NP-12-0021
May 31, 2012

Subject: Exelon Nuclear Texas Holdings, LLC
Victoria County Station
Early Site Permit Application
Environmental Report – Response to ER RAI Letter No.5
Docket No. 52-042

ESP EIS 9.3.1-1 (eRAI No.6394, RAI Letter No. 5):**NRC Request:****ESP EIS 9.3.1-1**

Figure 1 ERCOT Map with Depiction of Adequate Water Areas

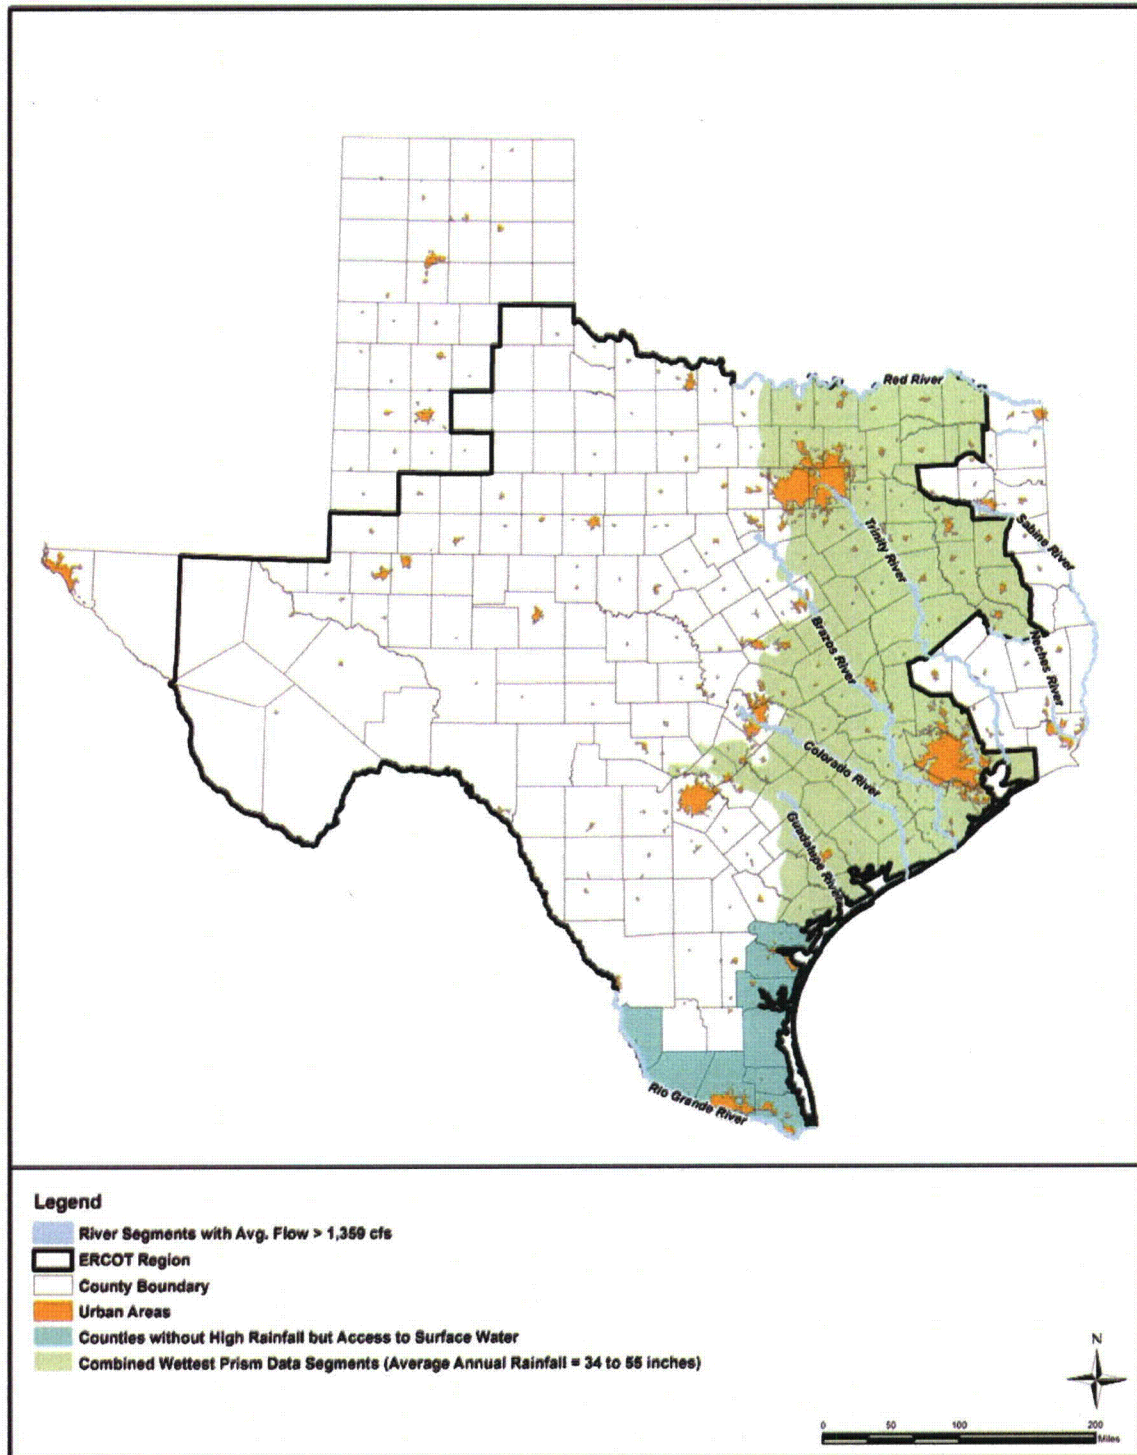
The ESRP Section 9.3 requires NRC to review the process by which the applicant has identified and evaluated alternative sites for the proposed action. Details of the applicant's site selection methodology must be available to support the NRC's evaluation of its reasonableness and to make sure that there is no other site that is obviously superior to the one being proposed by the applicant. This requires an analysis of alternative sites to support the determination of whether there is an obviously superior site in terms of overall environmental impacts and costs when compared to the site proposed by the applicant. Selection of candidate areas was separate from identifying and evaluating candidate sites and sufficient details of the decision-making process were not provided in the ER. Provide a discussion regarding the manner in which the candidate areas in the site selection process for the alternative sites were identified. Include all of the factors that influenced these selections and the values assigned to each criterion.

To verify that the "adequate water area" selected using the PRISM data was consistent with the site selection estimate of 61,000 gpm (135.9 cfs), Exelon analyzed surface water flow characteristics for major rivers in Texas using GIS data compiled by the U.S. Geological Survey (USGS 2003). Specifically, USGS gaging stations with an average daily stream flow greater than 10 times the estimated maximum consumption rate for the project (or average flow greater than 1,359 cfs) were identified. Applying a flow rate of 10 times the project requirement resulted in identifying river segments that have the physical availability of water to supply the new facility and a reasonable potential to acquire the necessary cooling water supplies. The gaging station most upstream on each major river meeting the flow requirement was identified as the point below which the river possesses sufficient flow to be identified as a viable cooling water source. The major rivers were then split into two segments at these locations: the upstream segment not meeting the flow requirement, and the downstream segment meeting the flow requirement. The river segments meeting the flow requirement are depicted in Figure 1, along with the adequate water area defined using the PRISM data.

Figure 1 indicates good correlation between the major river segments with sufficient flow and the wettest areas from the PRISM dataset, confirming the selection of the adequate water area. Figure 1 also shows that the lower portion of the Rio Grande River basin appears to have adequate physical water availability to support a new nuclear facility. Despite low average annual precipitation in the southern portion of Texas, the large size of the Rio Grande River watershed (approximately 176,000 square miles of contributing area) results in the observed average flow rates (RGRWPG 2006). Accordingly, counties in the lower Rio Grande basin were retained for further consideration.

Coastal counties not already within the adequate water area determined from the PRISM data were also examined as potential sites for saltwater cooled plants (see Figure 1).

Figure 9.3-2a. Counties Remaining After Application of Exclusion Criteria

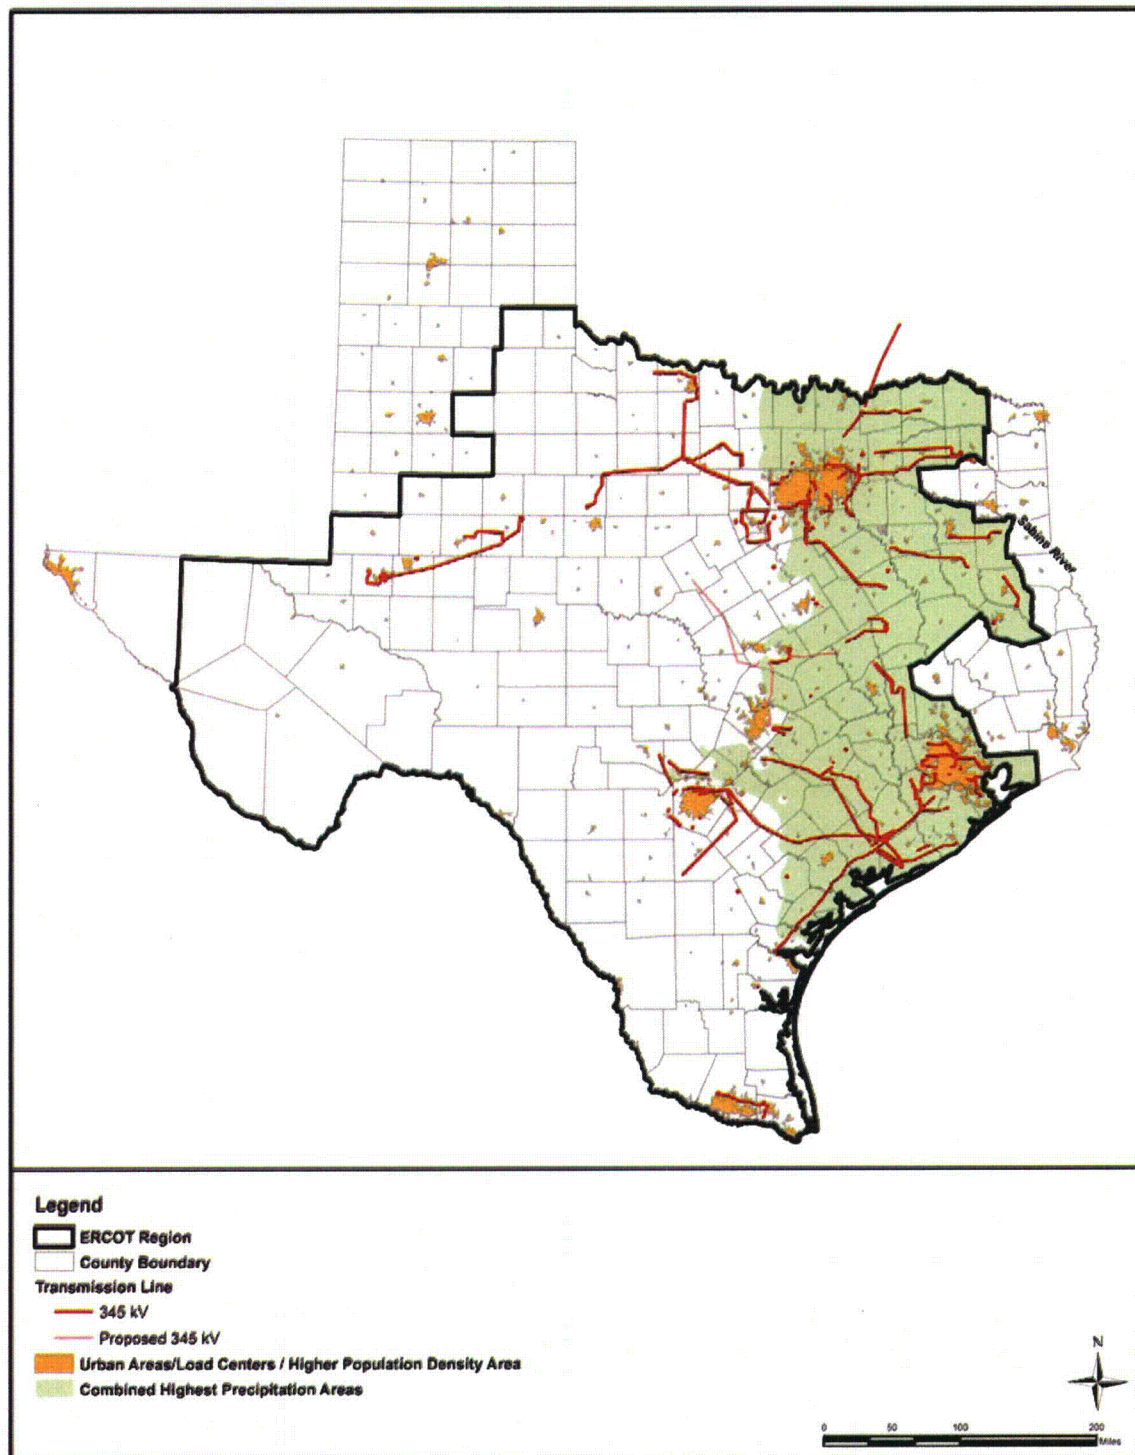
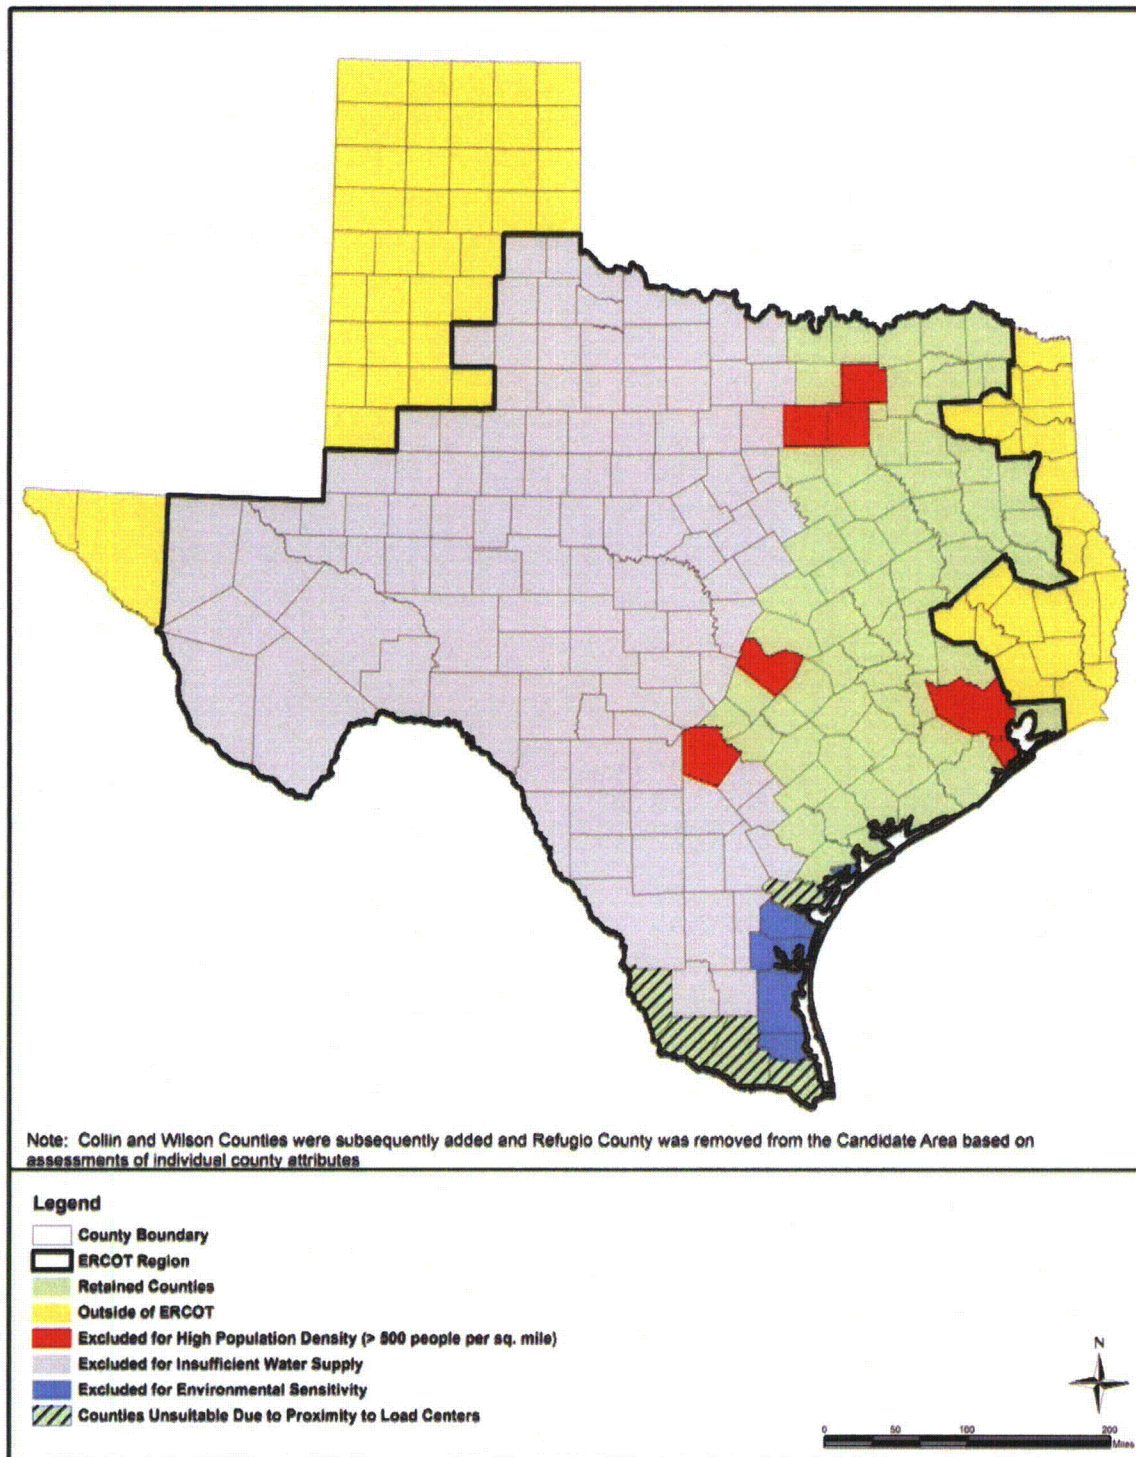
Figures 9.3-2 and 9.3-3 will be replaced with Figures 9.3-2a, 9.3-2b, and 9.3-3 in a future revision as indicated below.

9.3-2a and 9.3-2b summarize the application of exclusionary and suitability criteria during Candidate Area selection. Figure 9.3-3 presents the Candidate Area counties.
